Our ref: PLN-23-0059

Additional Information Required for Planning Application PLN-23-0059
Multiple Dwellings x 6 (6 New) (vary Site Area per Dwelling) at 7 Bedford Street, Campbell Town

PROJECT:
UNIT DEVELOPMENT

ADDRESS:
7 BEDFORD ST, CAMPBELL TOWN

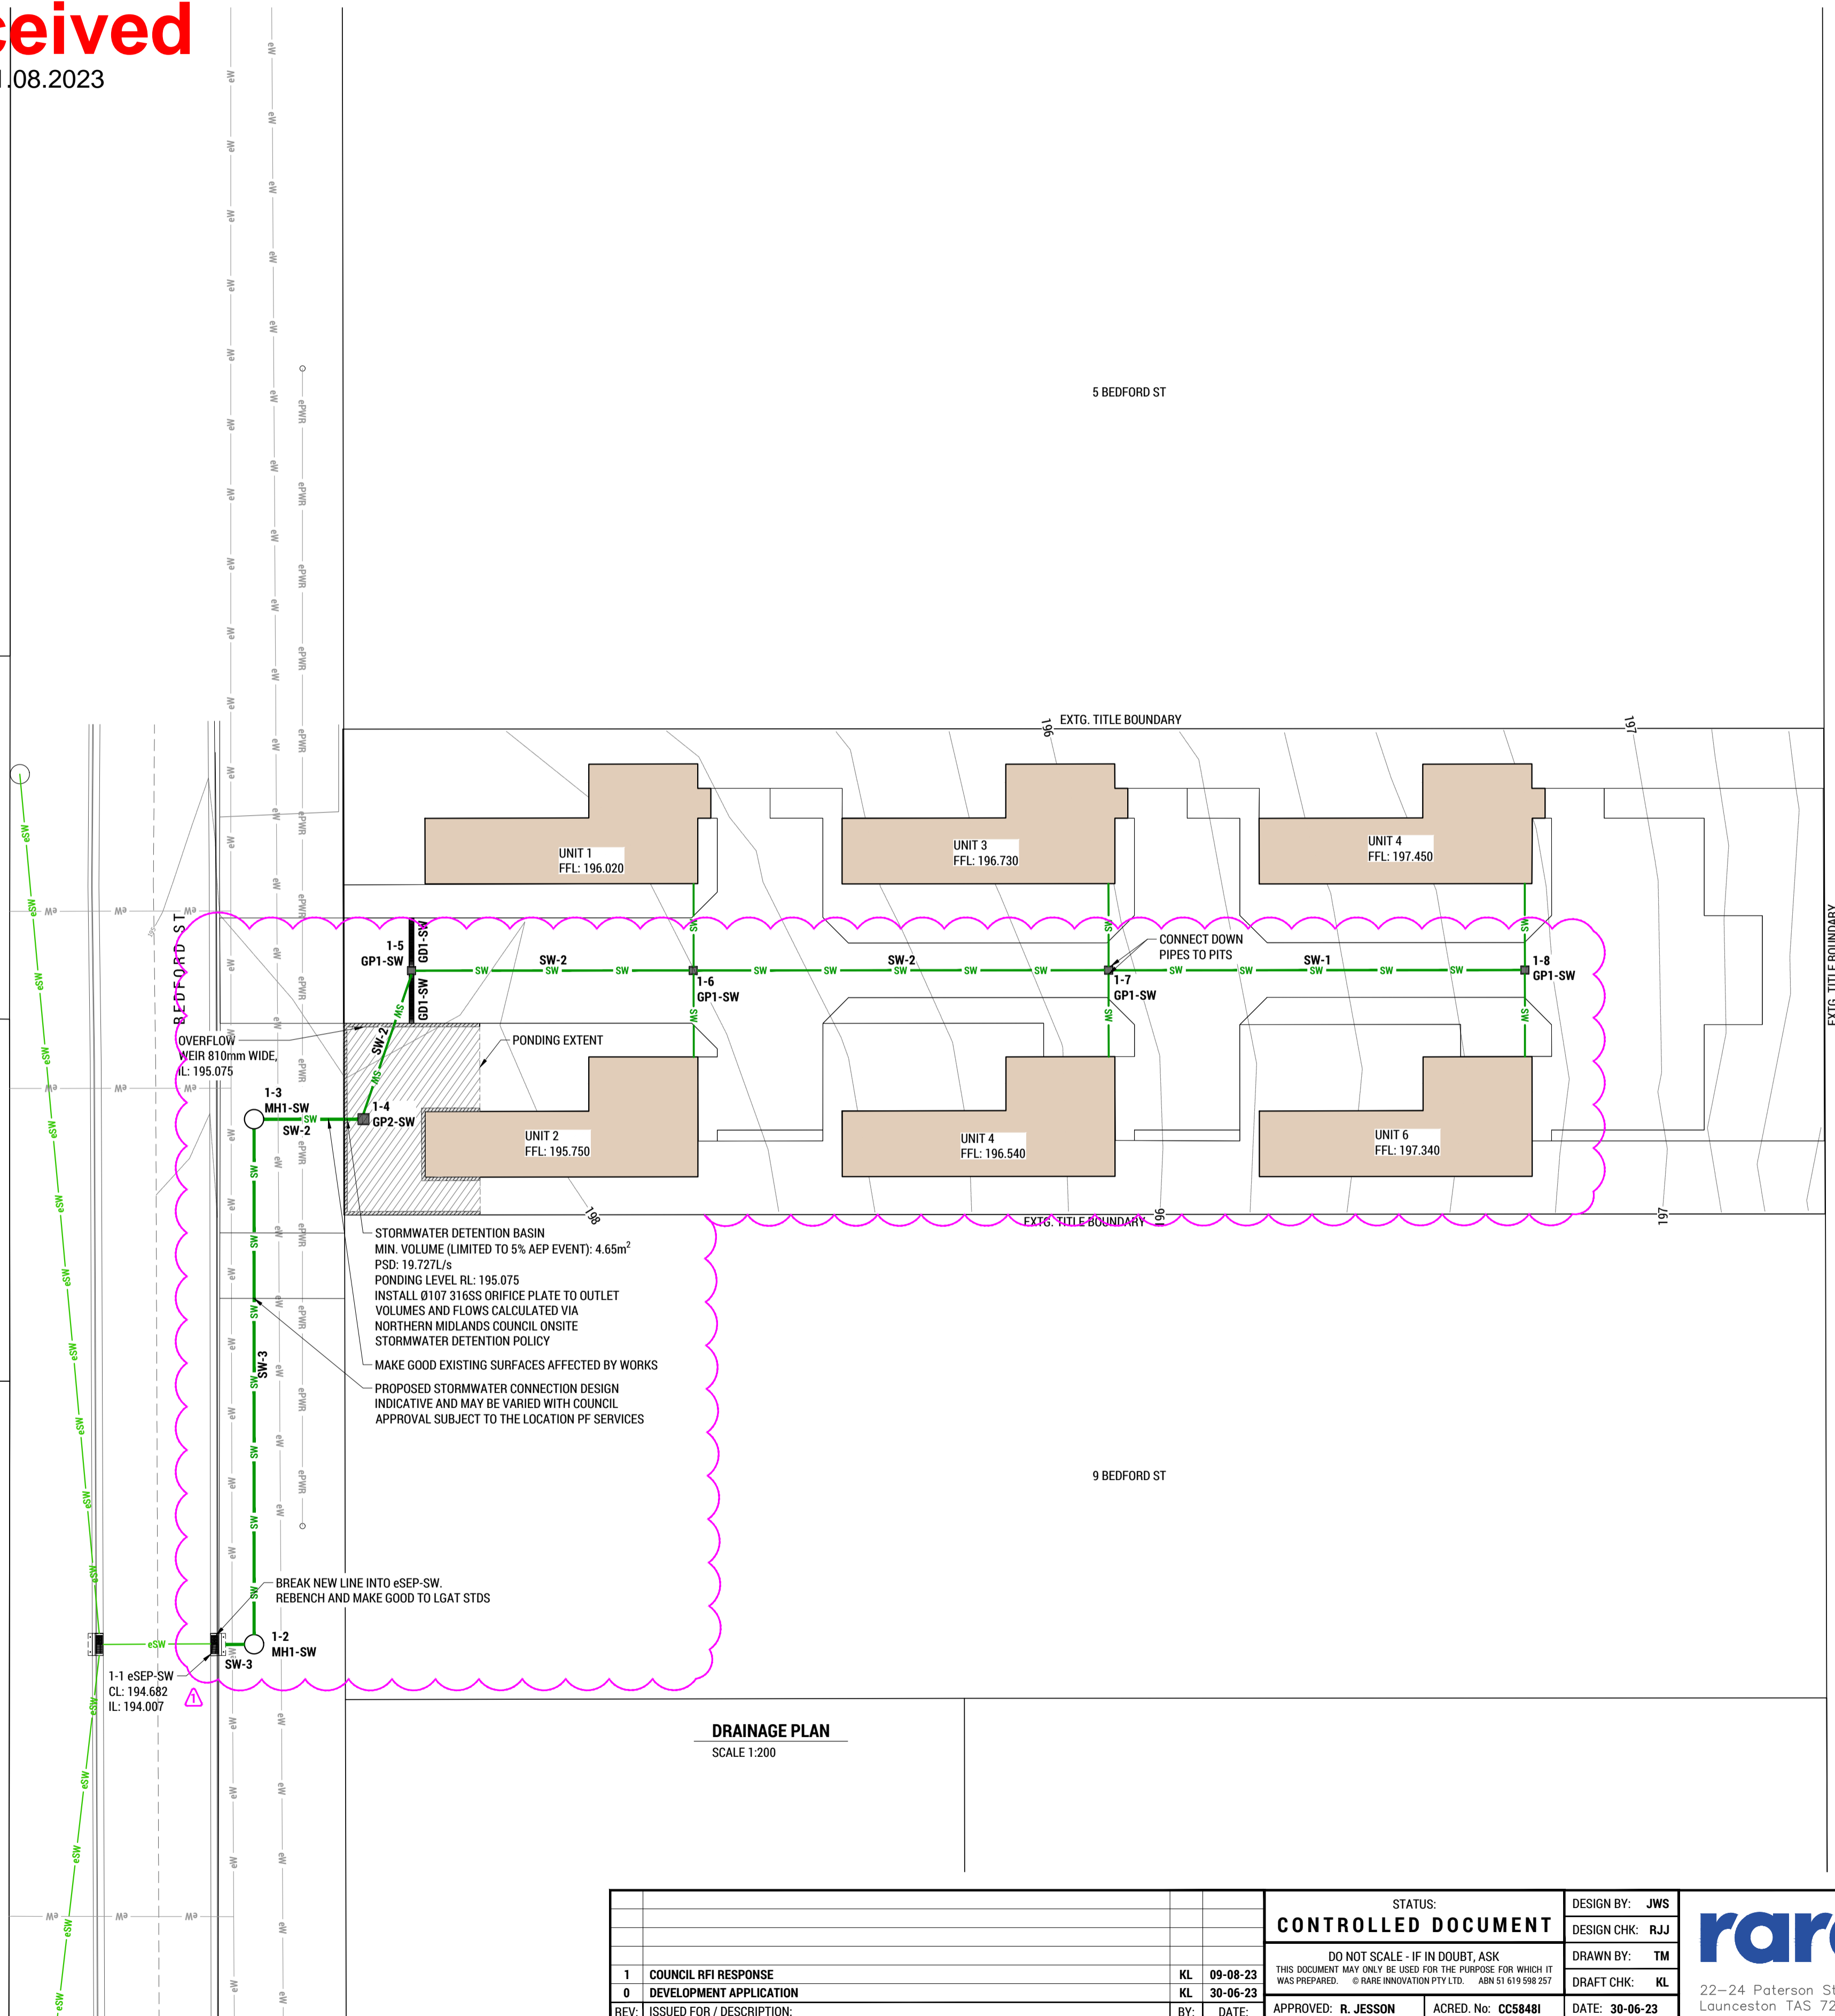
1. A breakdown of pervious and impervious areas.
2. The drawing shows an area of above ground detention in front of the house but there are limited details regarding depth, the proposed overflow weir etc. Also, Council's preference is underground detention where possible. Council would like you to look into whether this is possible.

3. Review the location of the 150mm pipe connecting to the side entry pit. The pipe across the naturestrip on an angle is not ideal. Council would prefer to install a separate manhole / pit at the back of the side entry pit with the pipe running parallel to the kerb. A second manhole / pit would also be required where connection turns to enter the property. There are several advantages to going this way – there is also a water main directly behind the kerb that might make access to the side entry pit difficult and going straight across the existing driveway next door rather than on an angle will mean that only part of the driveway not the whole driveway will need replacing. Alternatively you could look at going across the road in accordance with the previous tribunal ruling for PLN-21-0199.

An above ground detention storage area has been detailed to provide a minimum of 5m³ volume with an orifice of Ø107mm to be provided at the outlet to limit peak flows during the 5% AEP storm event to the PSD noted above of 19.73L/s. The maximum ponding level during this event is RL 195.075 with an overflow weir to be provided to control discharge of flows above the design storm event onto the driveway and subsequently onto Bedford Street. The lowest proposed floor level for the structures on site is RL 195.75, which is located a minimum of 300mm (675mm) above the maximum ponding level.

At Council's request, a partial below ground system was assessed to allow for storages of lower frequency events and prevent frequent ponding above ground. The required PSD for the system has been determined based on Council's requirements as noted above and subsequently the required orifice size. It has been determined that during events typically at or below 10% AEP (with a peak flow of approximately 16.3L/s), peak flows are less than the required PSD meaning that no detention will occur below this frequency. This means that an above ground solution will provide for the required 5% AEP storages while remaining clear during typically more frequent events. An outlet pit has been provided to allow for connection of piped infrastructure and regular flows.

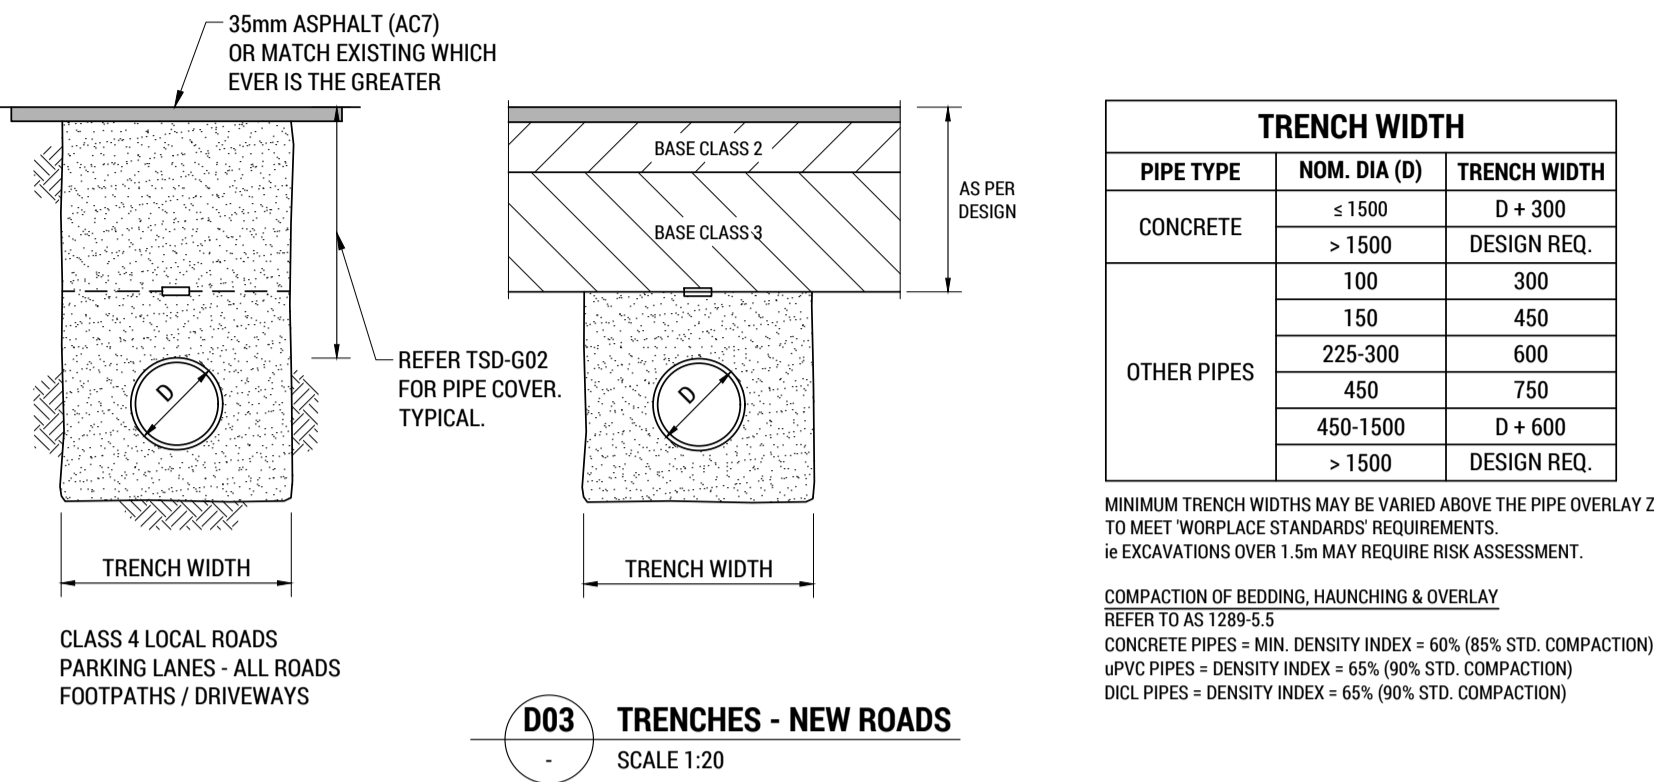
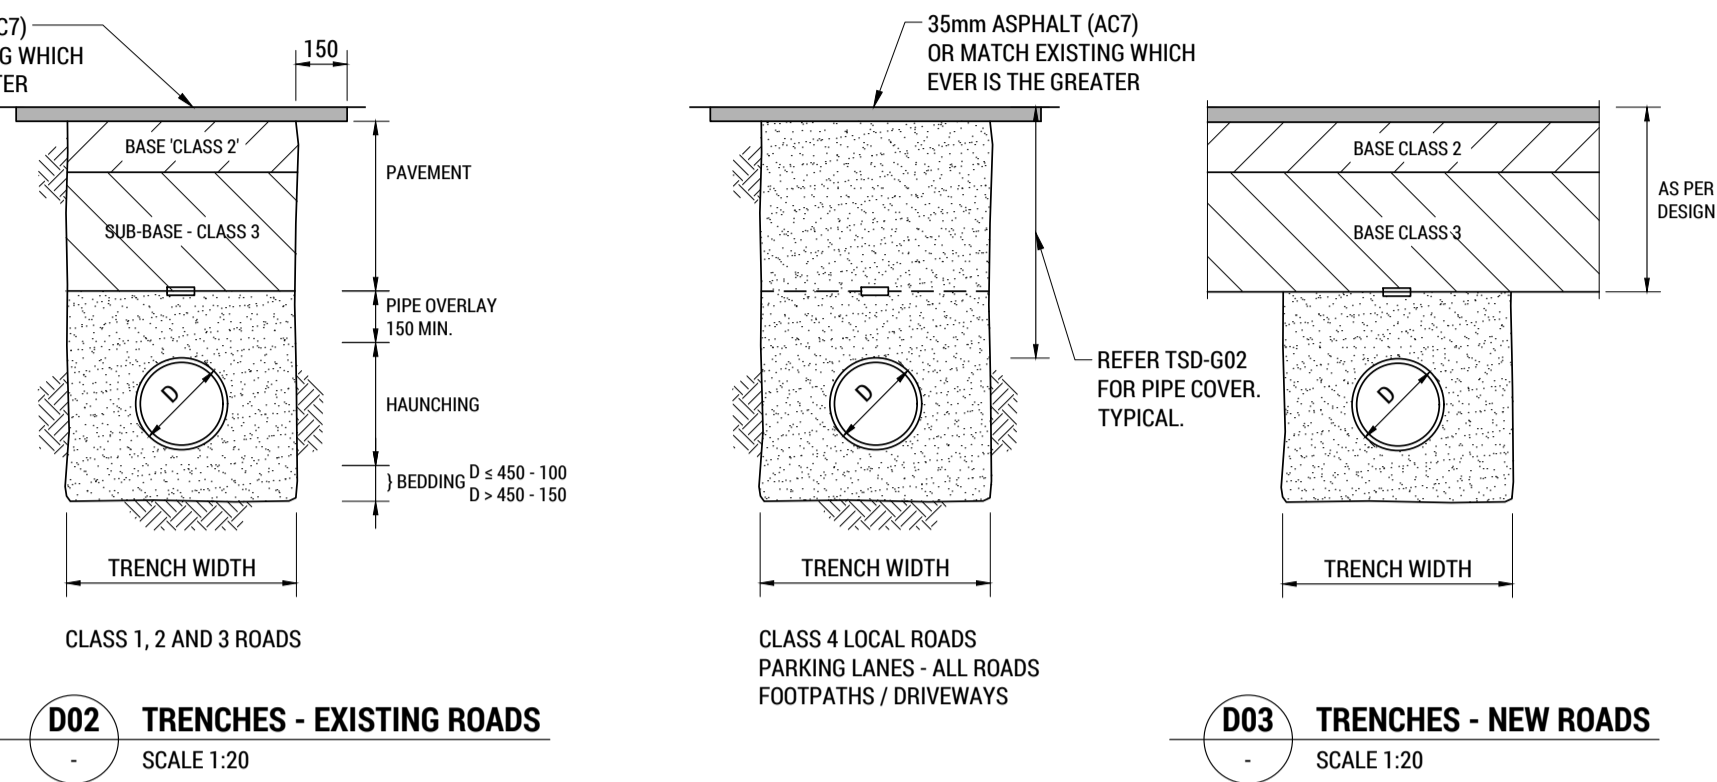
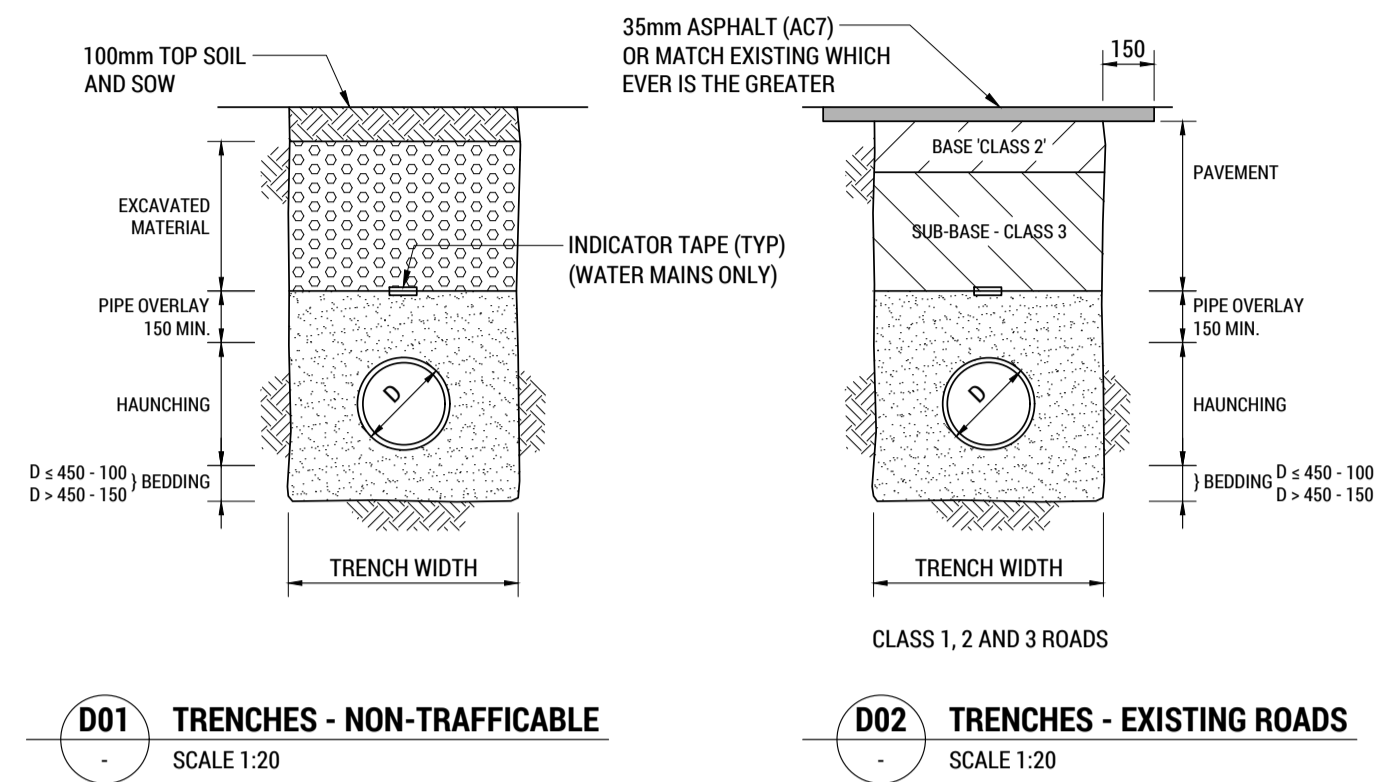
- Provide a stormwater report including calculations in accordance with Australian Rainfall and Run-off 2019.
- For the proposed detention in the driveway please provide details of when it is likely to hold water and how long for so Council can assess whether any other additional detention is required.
- Council requires a statement in the report referencing the levels and explaining why underground detention cannot be achieved here.

As shown on drawing C511 of the Rare project drawings, due to the levels of the existing public stormwater drainage infrastructure, depths to invert at the detention basin outlet from existing levels are only approximately 654mm which is insufficient to provide typical wholly below ground detention solutions such as tanks with adequate storage and cover.
